2.0 SAFETY LIMITS

DESCRIPTION: Ltr trans the following...change to tech specs...

ENCLOSURES: Proposed change to tech specs, notarized 2-27-74....

PLANT NAME: Monticello

FIGURE 2.1.1 FUEL CLADDING INTEGRITY SAFETY LIMIT

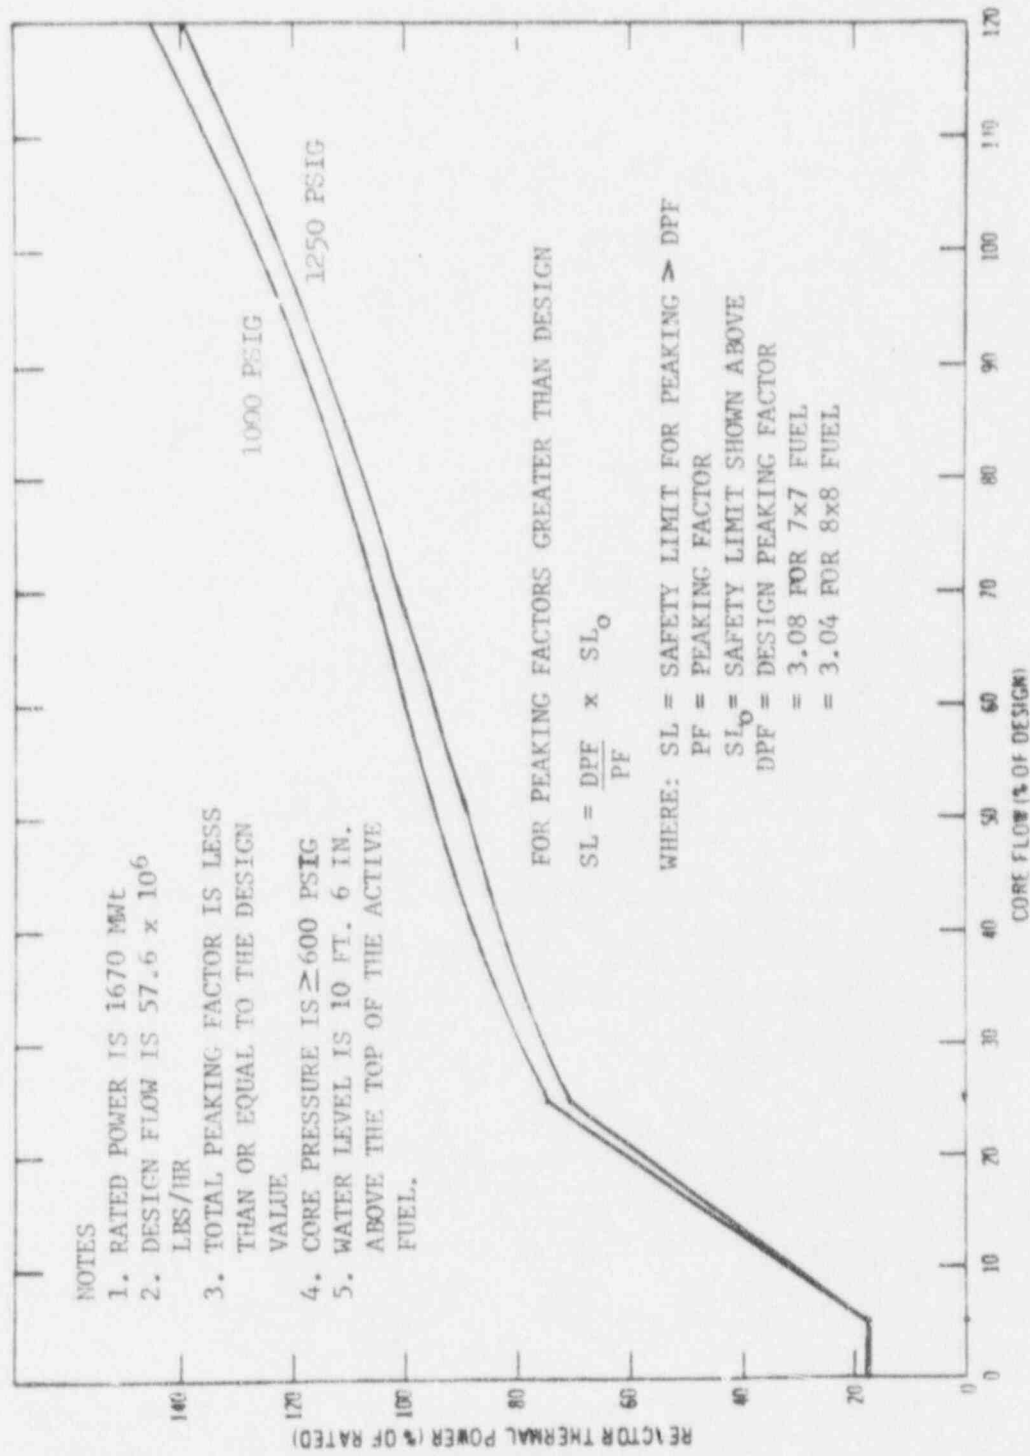
- A. When the reactor pressure is greater than 600 psig, the combination of reactor coolant core flow and reactor thermal power transferred to the coolant shall not exceed the limit shown in Figure 2.1.1. The safety limit is exceeded when the reactor coolant core flow and thermal power transferred to the coolant results in a point above or to the left of the limit line.

Curves are presented for two different pressures in Figure 2.1.1. The upper curve is based on a normal operating pressure of 1000 psig. The lower curve is based on a pressure of 1250 psig. In no case is reactor pressure ever expected to exceed 1250 psig, and therefore, the curves will cover all operating conditions with interpolation. If reactor pressure should ever exceed 1250 psig during power operation, it would be assumed that the safety limit has been violated. For pressures between 600 psig, which is the lowest pressure used in the critical heat flux data, and 1000 psig, the upper curve is applicable with increased margin.

The power shape assumed in the calculation of these curves was based on design limits and results in a total peaking factor of 3.08 for 7x7 fuel and 3.04 for 8x8 fuel. For any peaking of smaller magnitude, the curves are conservative. The actual power distribution in the core is established by specified control rod sequences and is monitored continuously by the in-core Local Power Range Monitor (LPRM) System. To maintain applicability of the safety limit curve, the safety limit will be lowered according to the equation given in Figure 2.1.1 in the rare event of power operation with a total peaking factor in excess of the design value.

The thermal hydraulic safety limit of Specification 2.1 was based on a total peaking factor of 3.08 for 7x7 fuel and 3.04 for 8x8 fuel. A factor has been included on Figure 2.1.1 to adjust the safety limit in the event peaking factor exceeds the design value. Likewise, the scram setting should also be adjusted to assure MCHFR does not become less than 1.0 in this degraded situation. This has been accomplished by use of Figure 2.3.2. If the combination of power and heat flux is greater than shown by the curve; i.e., a peaking factor greater than the design value exists, the APRM scram setting is adjusted downward by the formula given in the specification. The scram setting as given by the equation will prevent MCHFR from becoming less than 1.0 for the given heat flux condition for the worst expected transients. If the APRM scram setting should require a change due to an abnormal peaking condition, it will be done by increasing the APRM gain and thus reducing the slope and intercept point of the flow - biased scram curve by the reciprocal of the APRM gain change.

FIGURE 2.3.2

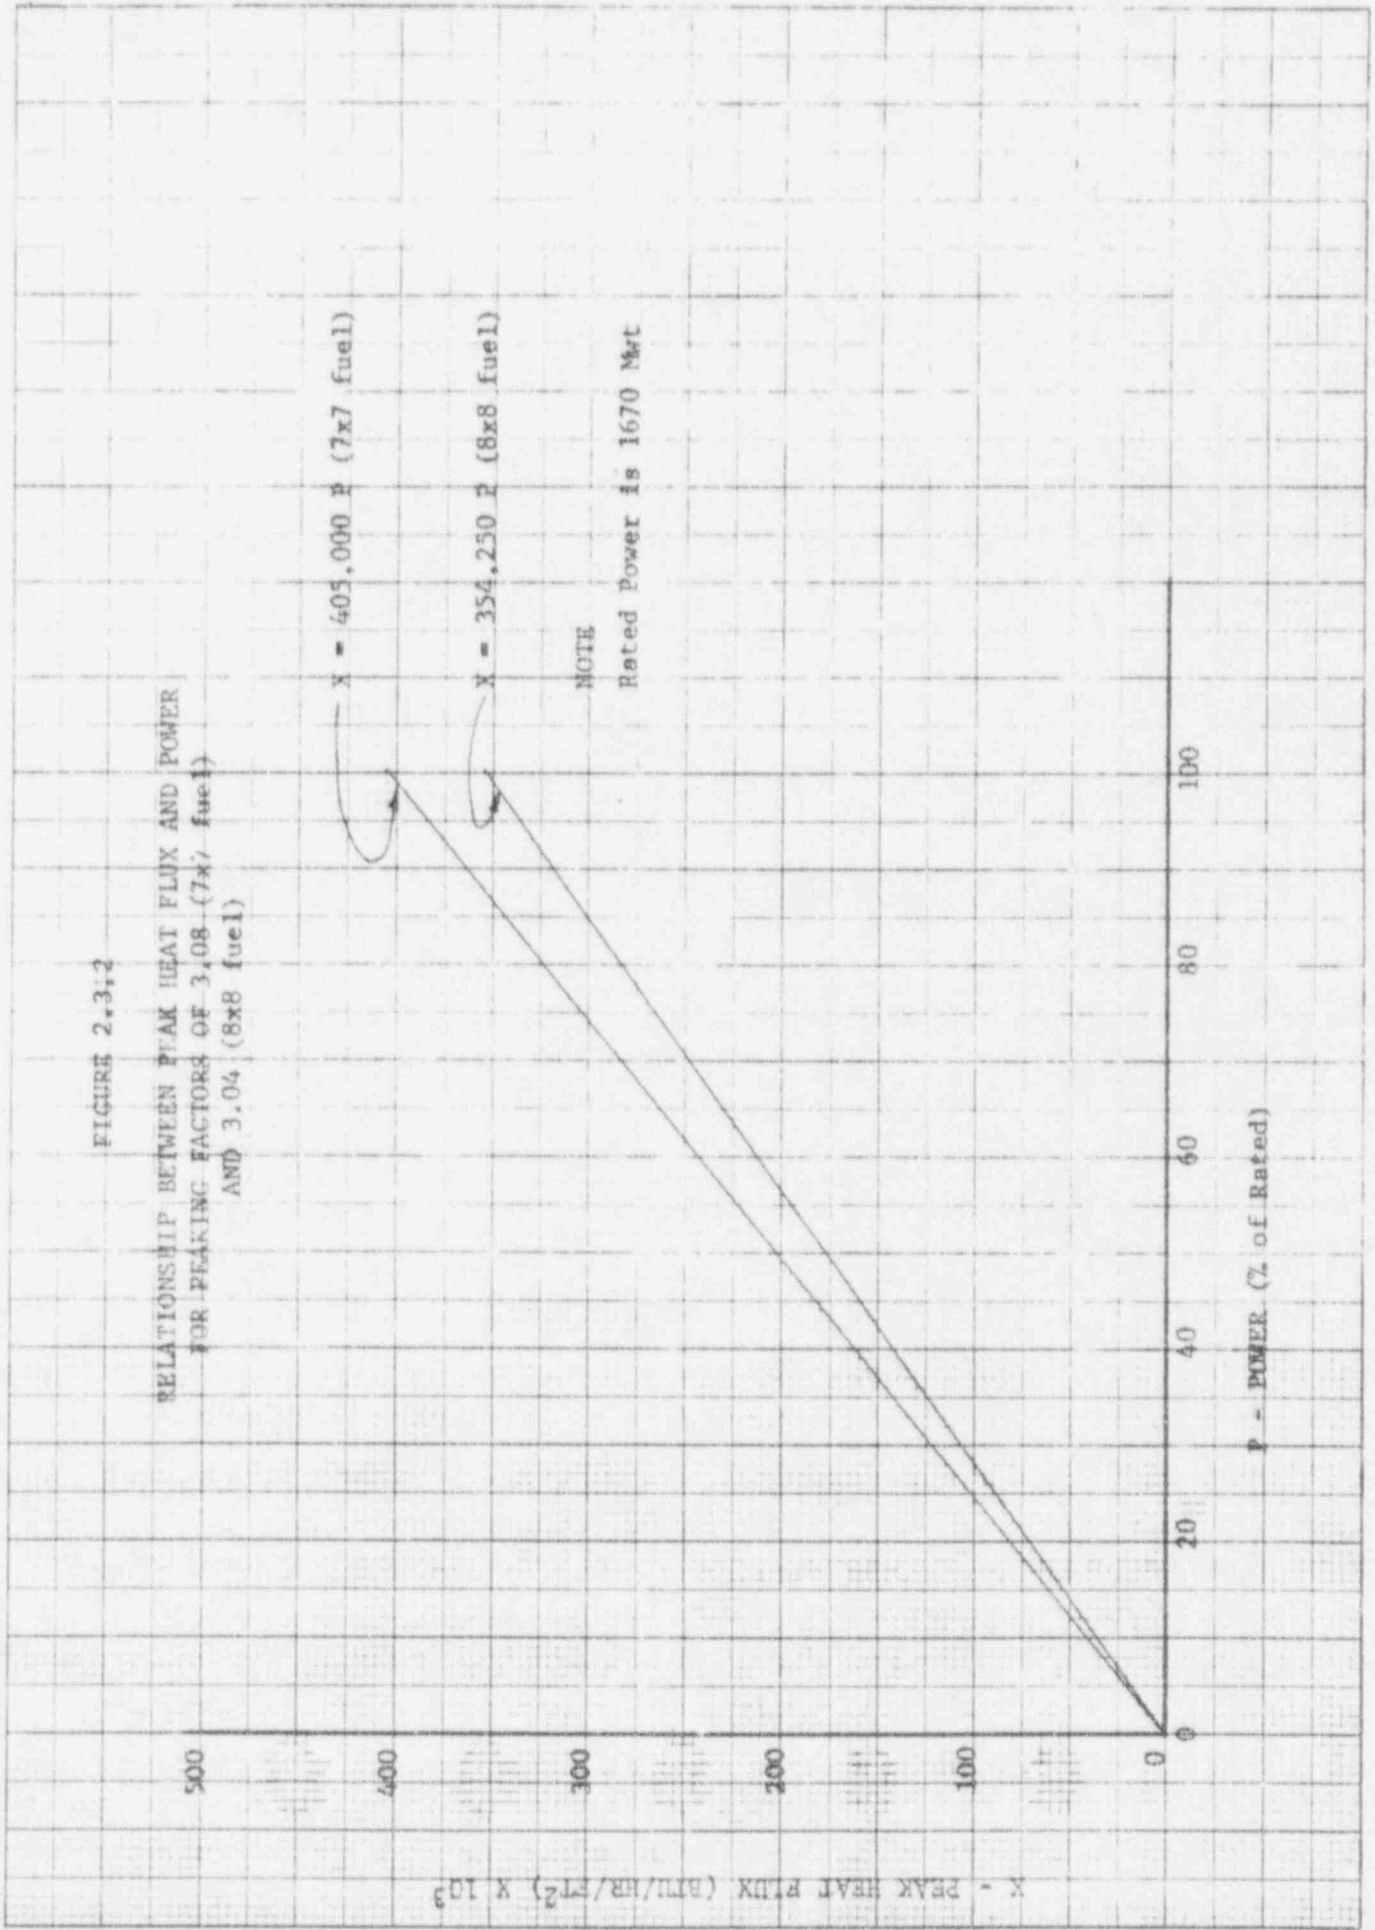
- A. Neutron Flux Scram
1. APRM -- The APRM flux scram trip setting shall be as shown in Figure 2.3.1 unless the combination of power and peak heat flux is above the applicable curve in Figure 2.3.2. When the combination of power and peak heat flux is above the curve in Figure 2.3.2, a scram setting (S) as given by:

B. APRM Rod Block - The APRM rod block setting shall be as shown in Figure 2.3.1 unless the combination of power and peak heat flux is above the applicable curve in Figure 2.3.2. When the combination of power and peak flux is above the curve in Figure 2.3.2, a rod block trip setting (RB) as given by:

RELATIONSHIP BETWEEN PEAK HEAT FLUX AND POWER
FOR PEAKING FACTORS OF 3.08 (7x7 fuel)
AND 3.04 (8x8 fuel)

$$S = \frac{485,000 P}{X} \quad (7 \times 7 \text{ fuel})$$

$$S = \frac{425,000 P}{X} \quad (8 \times 8 \text{ fuel})$$

$$RB = \frac{437,400 P}{X} \quad (7 \times 7 \text{ fuel})$$

$$RB = \frac{382,400 P}{X} \quad (8 \times 8 \text{ fuel})$$
